Dominion Transmission, Inc.
445 West Main Street, Clarksburg, WV 26301-2450
Mailing Address: P.O. Box 2450
Clarksburg, WV 26302-2450

RE: Notice of Probable Violation CPF 1-2012-1015

This letter is the formal response by Dominion Transmission, Inc. (DTI) to the Notice of Probable Violation dated May 29, 2012, in which five (5) separate items were identified during the 2009 inspection of the Bridgeport Storage Field. The following are DTI's response to each.

Figure 2.

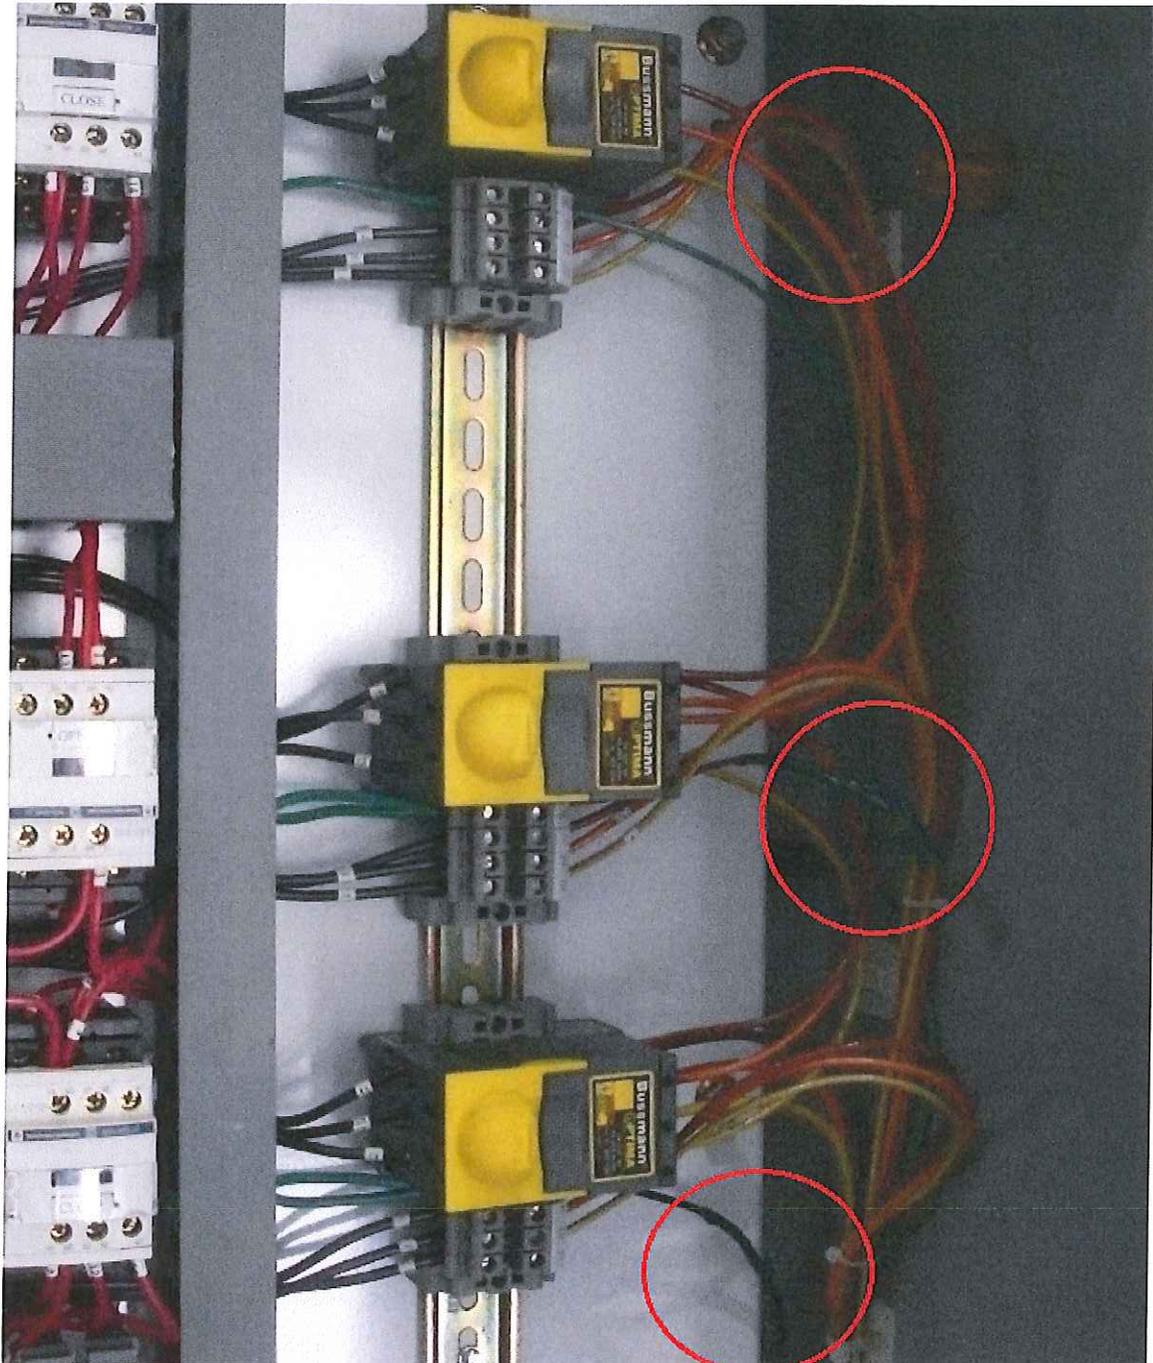
- “4. § 192.163 Compressor stations: Design and construction.
(e) *Electrical facilities.* Electrical equipment and wiring installed in compressor stations must conform to the National Electrical Code, ANSI/NFPA 70, so far as that code is applicable.**

Pursuant to NEC Article 230.57 (b), “Individually covered or insulated equipment grounding conductors shall have a continuous outer finish that is either green or green with one or more yellow stripes.

DTI failed to have grounding conductors with a continuous outer finish that is either green or green with one or more yellow stripes. The grounding wires for the motor control center for the suction, discharge, & bypass of compressor engine number 1 in the Bridgeport Compressor Station had a red continuous outer finish.”

The NEC Article referenced in Item #4 is not present in the version (NEC 2008) of the document incorporated by reference in 49 CFR Part 192. However, DTI has performed an evaluation of the grounding conductors associated with the “motor control center for the suction, discharge, and

bypass of compressor engine number 1.” That evaluation revealed that the wires in question are marked with green tape (see Figure 2 below, grounding conductors circled in red), which adequately identifies them as grounding conductors. For this reason, DTI respectfully requests the withdrawal of Item #4, and the associated proposed civil penalty.
